ADDENDUM NO. 3

Three Rivers Community Schools – Three Rivers Middle School Additions and Renovation
1101 Jefferson Street
Three Rivers, MI 49093

This Addendum forms a part of and modifies the Bidding Requirements, Contract Forms, Contract Conditions, the Specifications, and the Drawings dated December 1, 2022, by GMB Architecture and Engineering. Acknowledge receipt of the Addendum in the space provided on the Bid Form. Failure to do so may subject the Bidder to disqualification.

Item No. 1

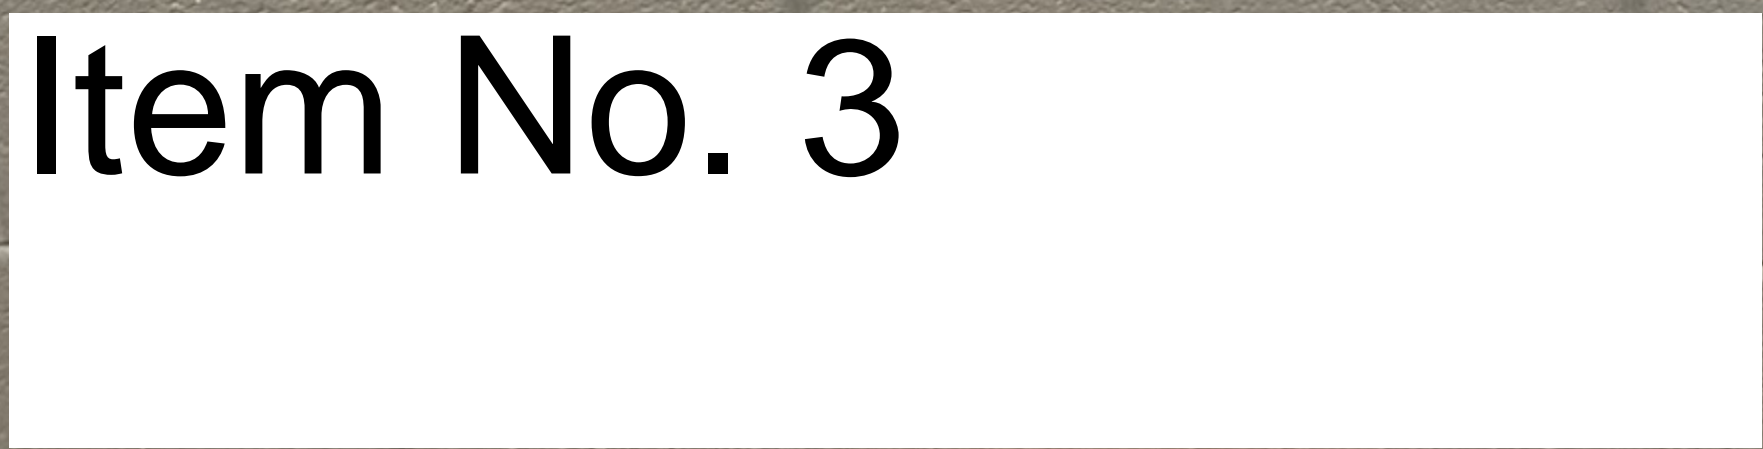
9. See attachment No. 1, Item No. 1. **Bid Category No. 15 Electrical** is to Provide covering of Existing Fire Alarm Panel during the course of construction.
